MAILBU APARTMENTS - DESIGN ALTERATIONS REQUEST
2024-08-29

SITE PLAN - OVERALL

SHEBOYGAN KITE BEACH
MALIBU APARTMENTS, LLC
SHEBOYGAN, SHEBOYGAN COUNTY, WI 53081

SHEET NUMBER
C200

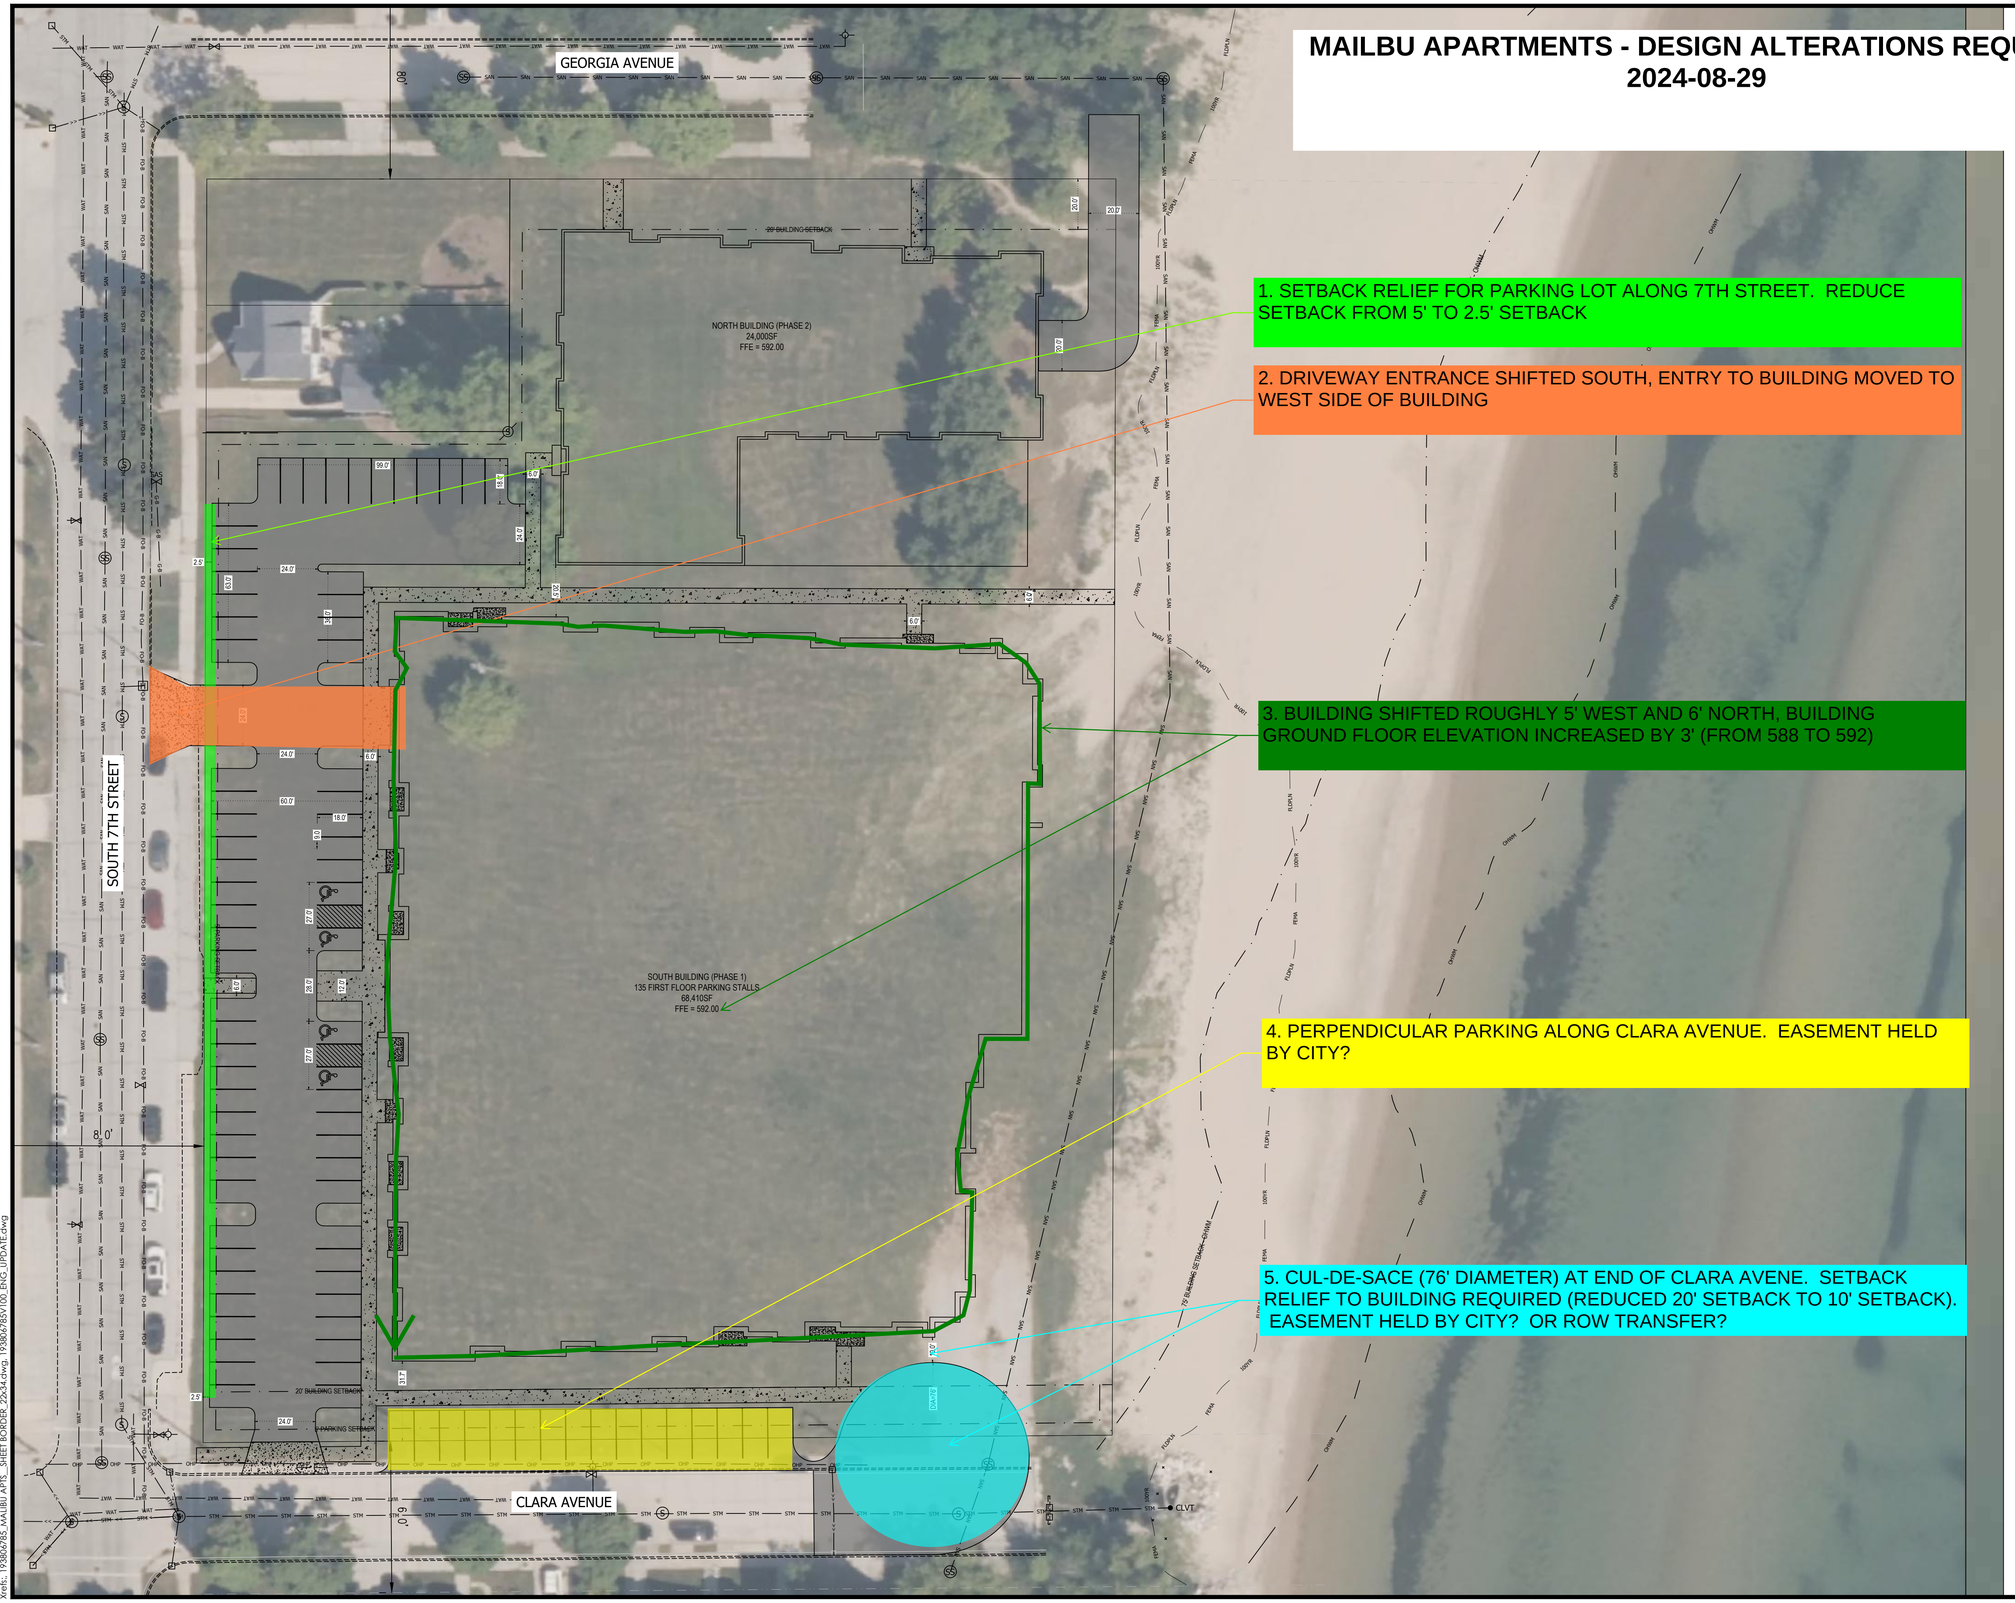
1. SETBACK RELIEF FOR PARKING LOT ALONG 7TH STREET. REDUCE SETBACK FROM 5' TO 2.5' SETBACK

2. DRIVEWAY ENTRANCE SHIFTED SOUTH, ENTRY TO BUILDING MOVED TO WEST SIDE OF BUILDING

3. BUILDING SHIFTED ROUGHLY 5' WEST AND 6' NORTH, BUILDING GROUND FLOOR ELEVATION INCREASED BY 3' (FROM 588 TO 592)

4. PERPENDICULAR PARKING ALONG CLARA AVENUE. EASEMENT HELD BY CITY?

5. CUL-DE-SACE (76' DIAMETER) AT END OF CLARA AVENE. SETBACK RELIEF TO BUILDING REQUIRED (REDUCED 20' SETBACK TO 10' SETBACK). EASEMENT HELD BY CITY? OR ROW TRANSFER?
